**ASHLAND PLANNING DEPARTMENT
PRE-APPLICATION CONFERENCE
COMMENT SHEET**
September 7, 2022

SITE: Kestrel Park Apartments
APPLICANT: KDA Homes, LLC
REQUEST: Outline Plan for 14 lots
Site Design Review
Exceptions (?)

Figure 18.3.5.100.C.2. Neighborhood Access Street

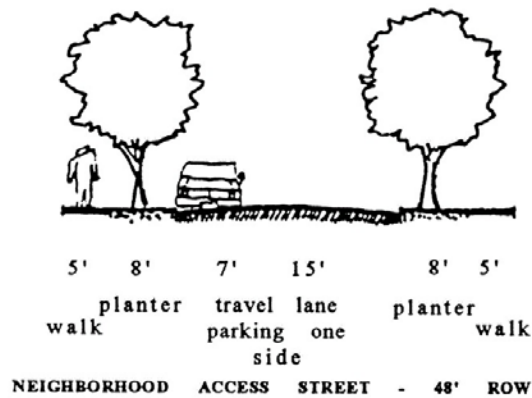
Note: *It appears that the eight-foot planter called for includes the standard curb width. The curb width should be considered in cross-sections.*

Figure 18.3.5.100.C.3. Alley

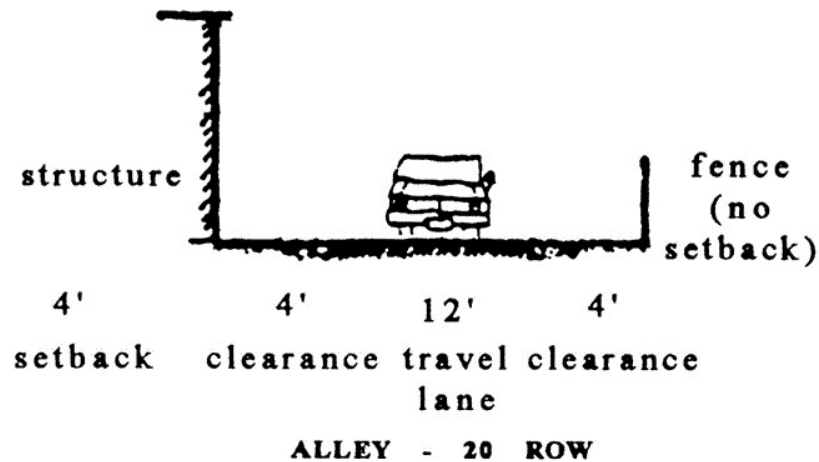
- Alleys were discussed at Outline Plan and the Commission determined that they needed to be installed to the full NMNP standard cross-section below, **including the full four-foot width shoulders:**
